MEMORANDUM

[REDACTED] STAT
SUBJECT 9-1/2" BLACK AND WHITE [REDACTED] PROCESSOR MODIFICATIONS
COPIES [REDACTED] file (2) STAT
STAT

The following changes of the 9-1/2" black and white [REDACTED] processor are the approaches we are planning to produce a properly functioning system. These changes will enable us to process film [REDACTED] adequately. [REDACTED] STAT
STAT
STAT

REPLENISHMENT MODIFICATION

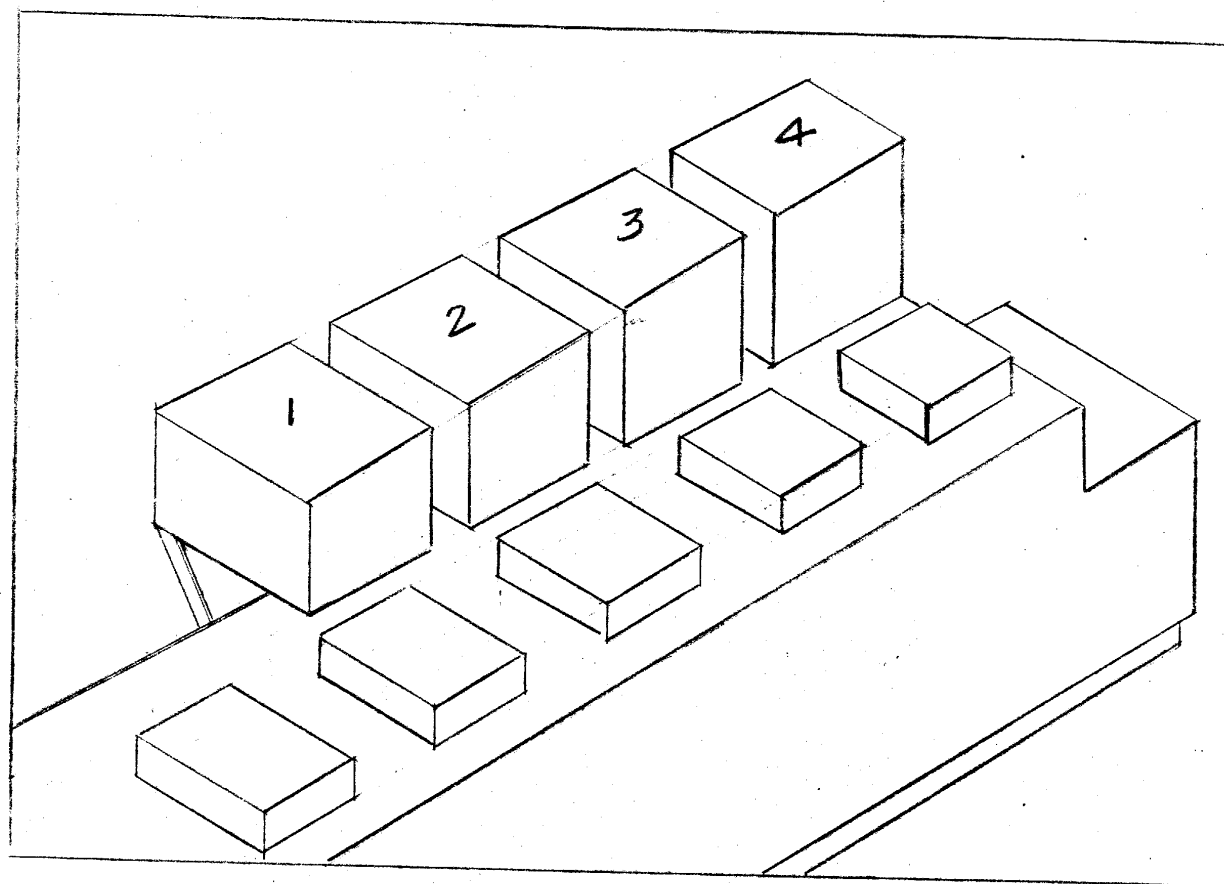
The replenishing system will consist of replenishing tanks sufficient in size to process 500 feet of film, (Figure 1) These tanks will be installed above the processor which will provide the required head pressure to operate the flow meters. Each processing module will be modified by the addition of overflow stand pipes. The replenishing tank supports will be permanently mounted on the processor. The replenishment tanks shall be detachable for ease of maintenance. Each tank will be furnished with a lid to reduce aerial oxidation and evaporation.

INFARED DRYER MODIFICATION

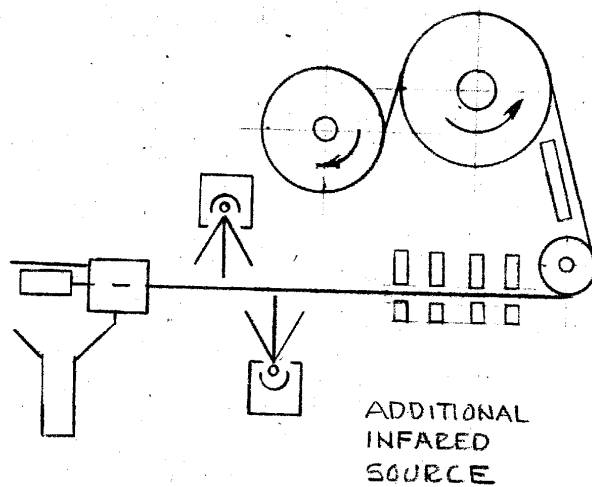
A. The simplest modification appears to be the addition of a second infra red source which will be installed so that the radiation is applied to the emulsion side of the film. (Figure 2.) Approximately one-half of the existing air knives will be removed to facilitate the installation of a second infra red source. The existing cooling system should be sufficient to accommodate this additional load. It may be necessary to provide a second voltage control unit.

PLENUM DRYER MODIFICATIONS

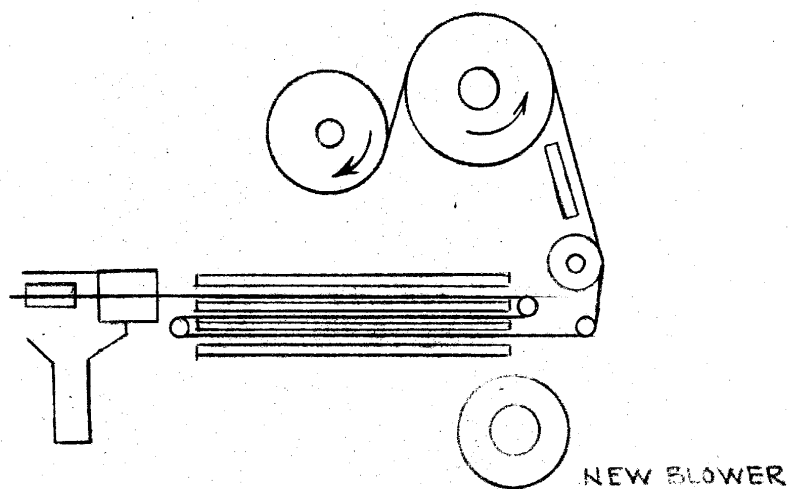
B. The second design approach will require extensive modification to the takeup end of the processor. These modifications will consist of removing the infra red source air knives and supporting equipment. This system as shown in Figure 1 will be of the heated air impingement plenum type and will consist of three air plenums and the associated

rollers required to guide the film. As this type of dryer will require more air, the existing blower will be used for the wet section only, further reducing carryover. An additional blower will be used for the dryer section. This dryer blower will be housed inside the available space under the vacuum capstan, therefore no increase in processor length is anticipated. (Figure 3.)
